Re: KTK Landfill

Further to your correspondence of the 22nd September 2010 please find enclosed Sanitary Authority Consent Conditions for the Review of Waste License W0081-04 for KTK Landfill Ltd, Brownstown & Carnalway, Kilcullen, Co. Kildare for your approval.

RE: Leachate Treatment

**PROPOSAL FOR SPECIFIED ENGINEERING WORKS:
KTK LANDFILL, KILCULLEN, CO. KILDARE.
WASTE LICENCE W0081-03**

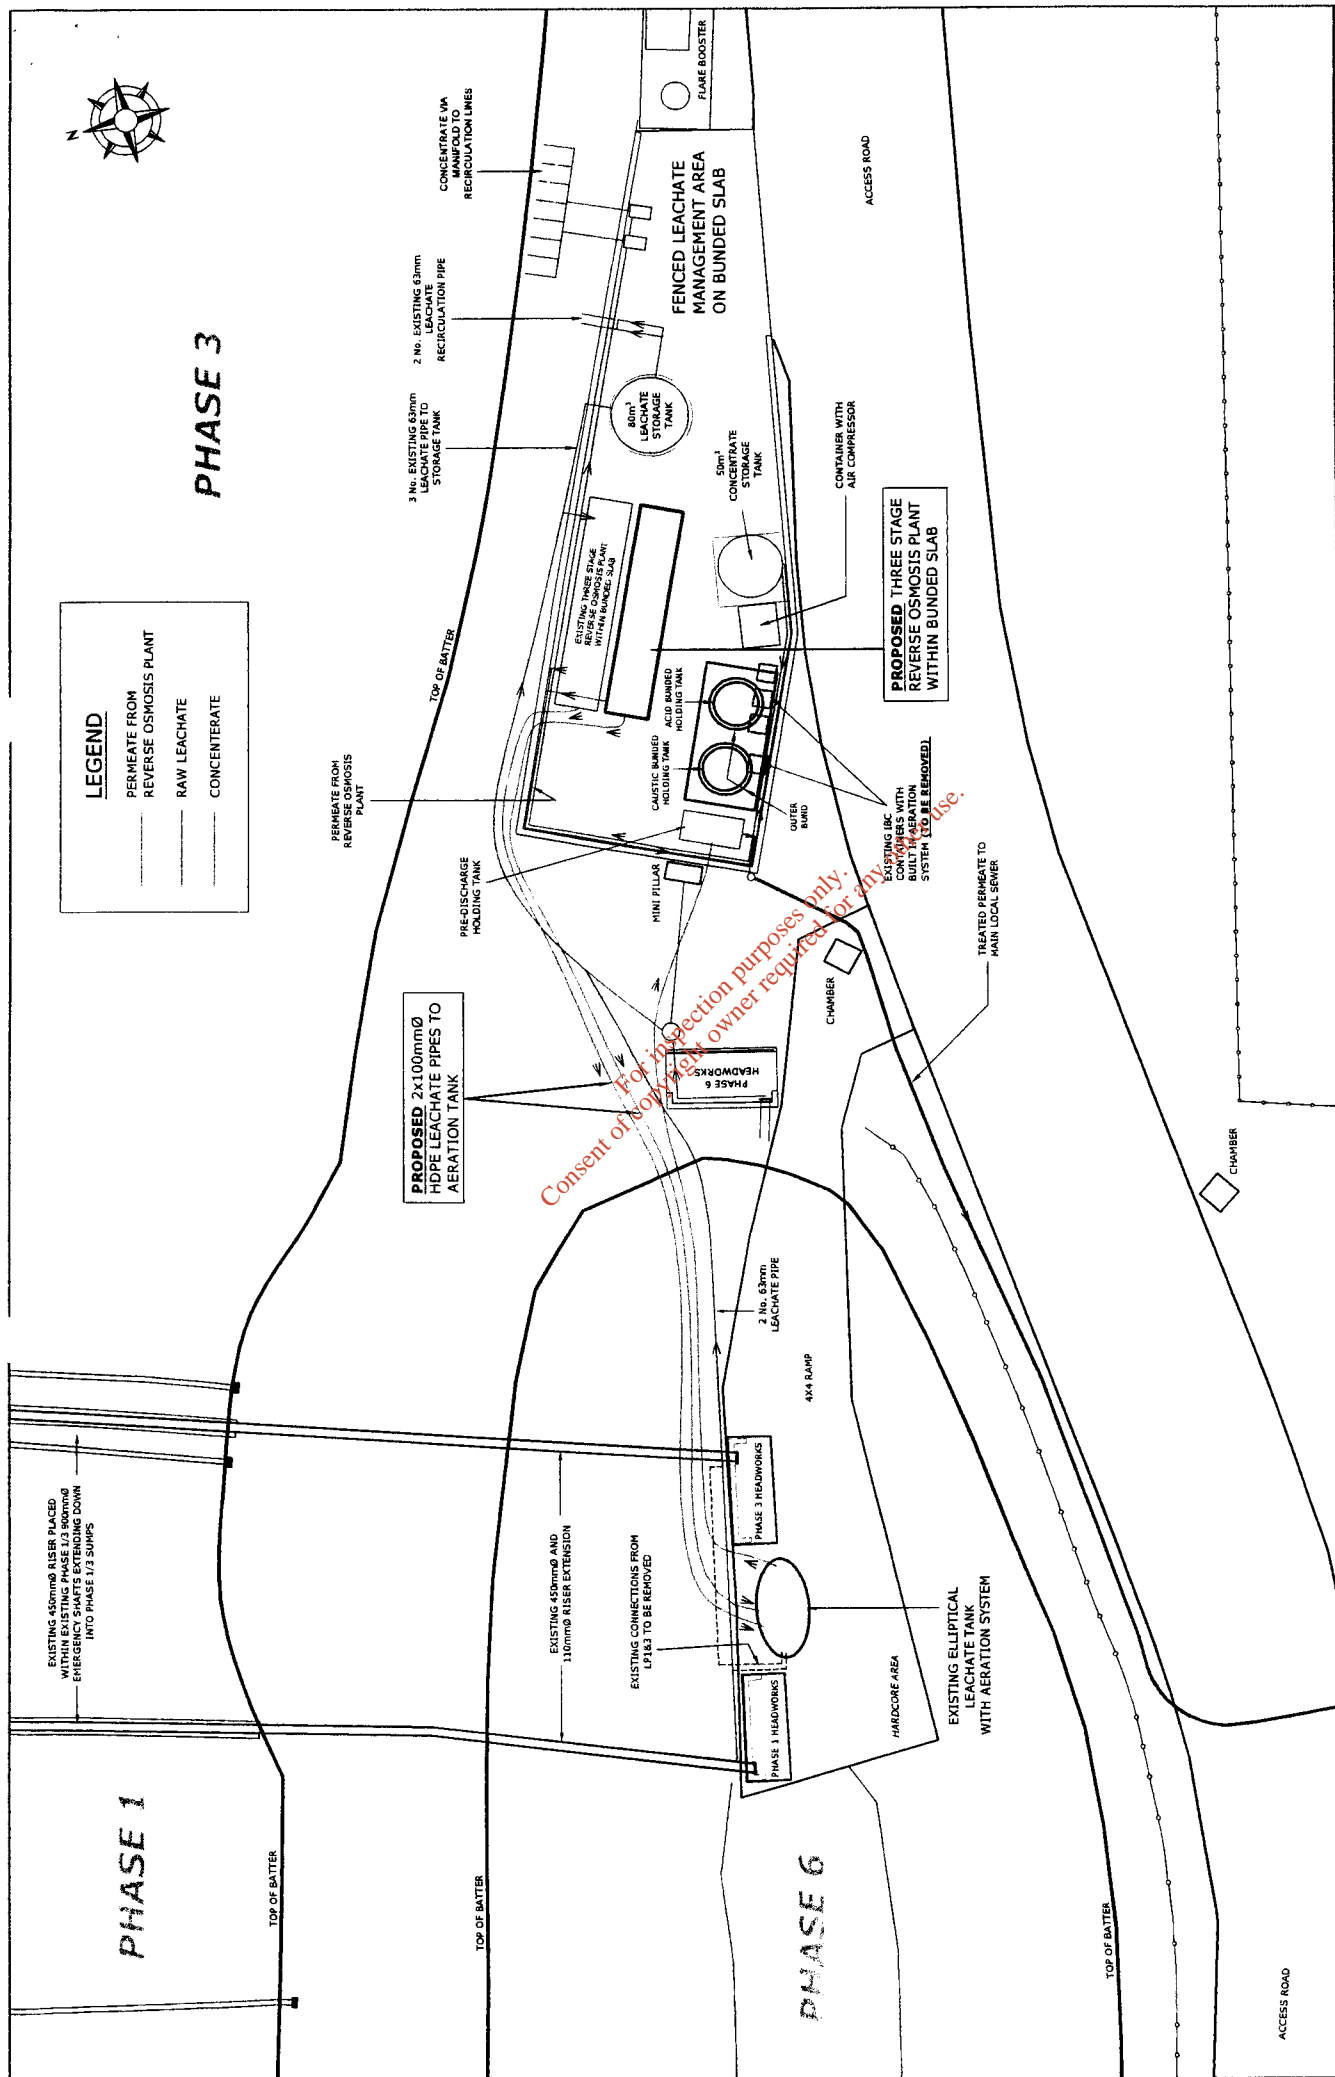
2. The network of wells (GW208, GW75, GW41, GW79, GW100, GW224, GW86, GW187, GW197, GW128 and GW 231 as set out in Figure RO 02/01 "*Leachate and Concentrate Re-Infiltration System*" shall be adapted as set out in Section 4.2.2 and dipped for leachate level as proposed. This should be done on a monthly basis for the first three months post this correspondence and quarterly thereafter. A separate report on the first months monitoring should be submitted to the Agency and shall include borehole drilling/constructions logs and appropriate cross-sections and schematics demonstrating their construction in relation to the base of the landfill and the landfill surface. A minimum of a weekly level measurement reading for leachate sumps LP1, LP3 and LP6 shall also be reported in the Quarterly Reports.
